Bulletin Ref: TB30a

Vauxhall

AAL1407

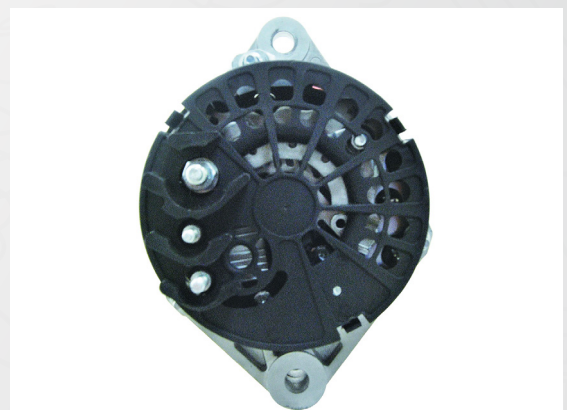
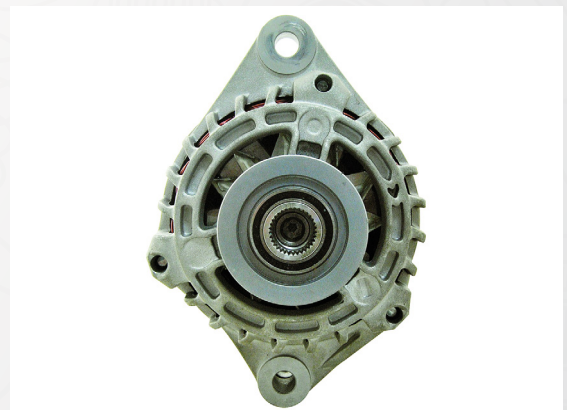
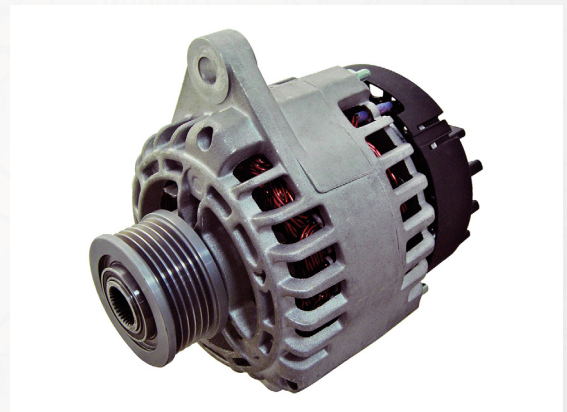
This is the earlier non 'smart charge' unit with stud fitting on the rear.

Vauxhall 1.9 CDTi models from 2007 use a 'smart charge' unit which has a 2 pin multiplug connector on the rear, these will not interchange.

Please double check before ordering.
